NOTICE OF DECISION

TAX LOT: 2S133BB00100 / 2S1330000400
CASE NO: LU 2023-017 SP / CUP
Rock Creek Industrial (Panattoni)
DATE OF NOTICE: March 19, 2024

CITY OF SHERWOOD
March 19, 2024
PLANNING COMMISSION FINDINGS

Rock Creek Industrial (Panattoni)
SITE PLAN REVIEW & CONDITIONAL USE PERMIT
LU 2023-017 SP / CUP

PRELIMINARY SITE PLAN

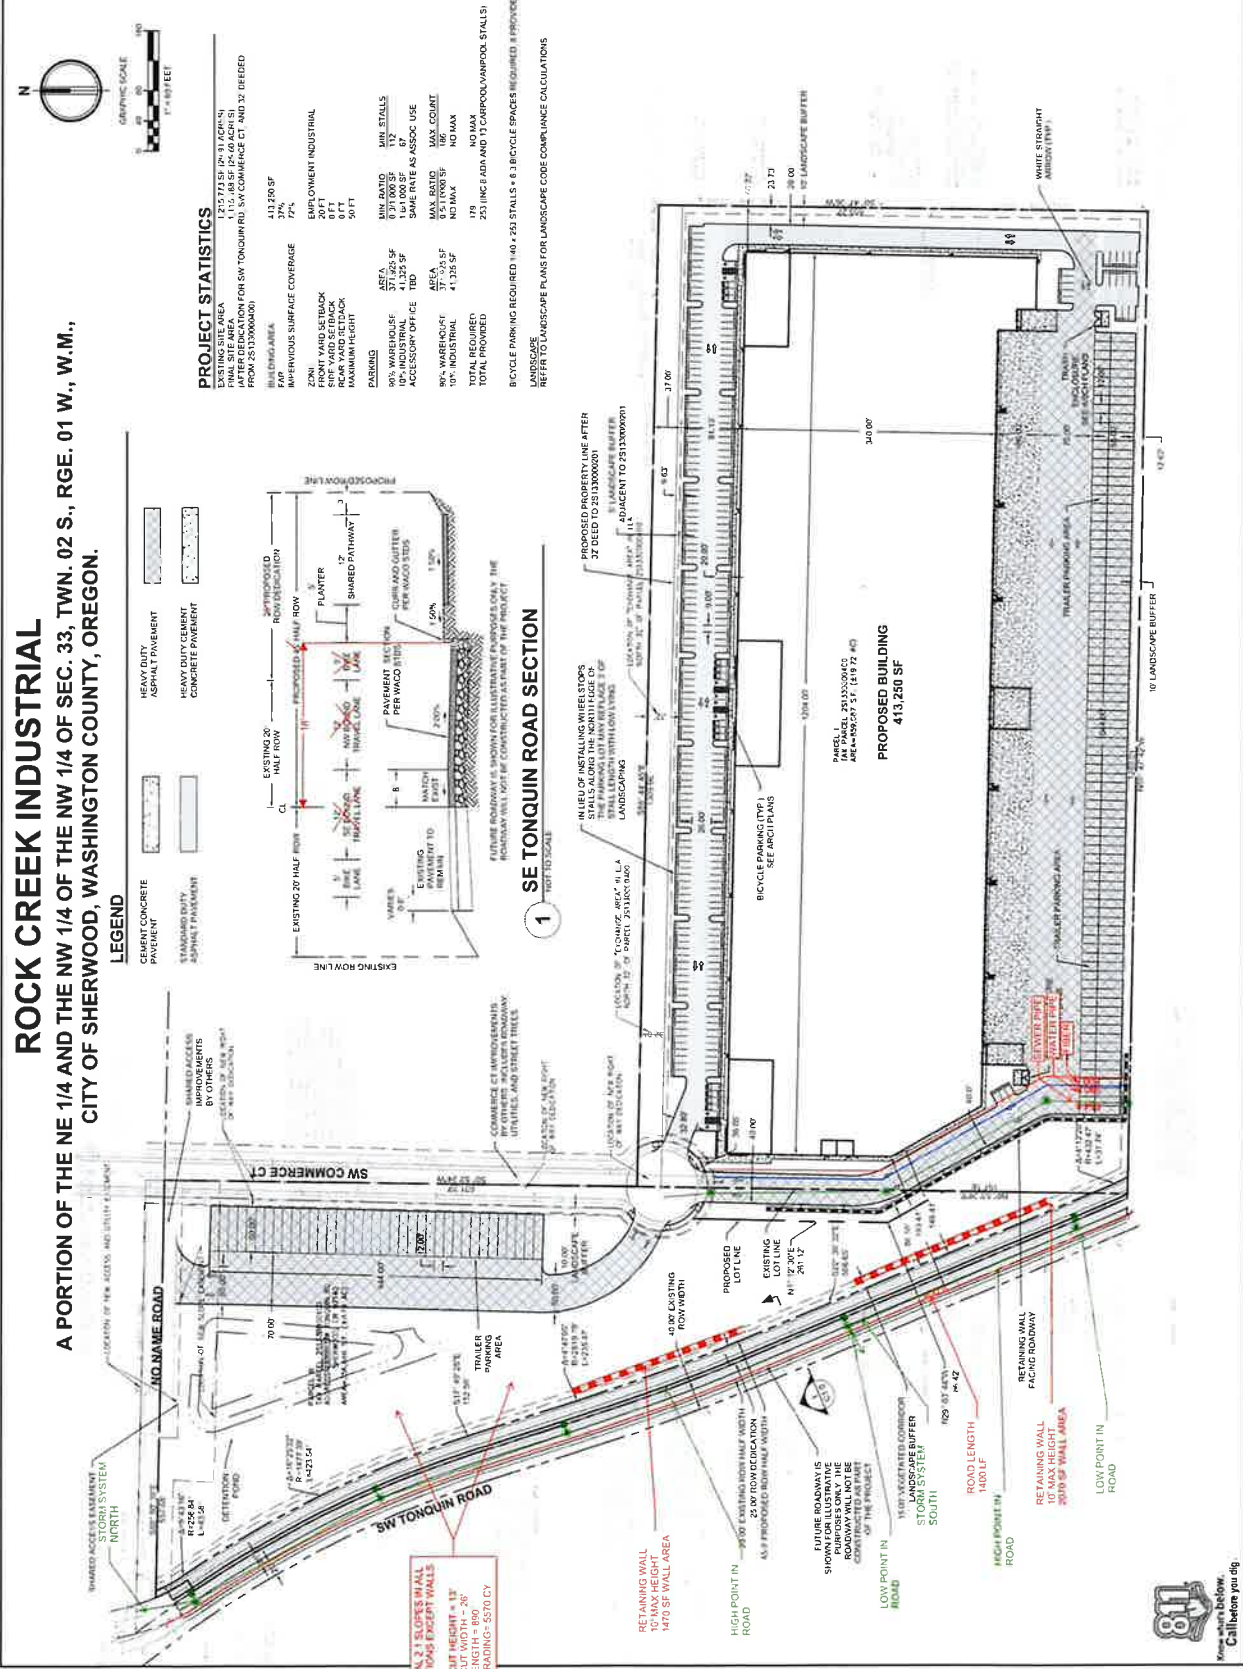
According to Sheet No. C1.1 of the Rock Creek Industrial Site Plan Review in the updated civil plans document submitted as part of this application, the earthwork quantities indicate 109,000cy of excavation. All material excavated onsite must be used onsite or an Operating Permit is required. The proposed excavation is located on a taxlot 100, which is not incorporated in DOGAMI ID 34-0011 that covers tax lot 400.
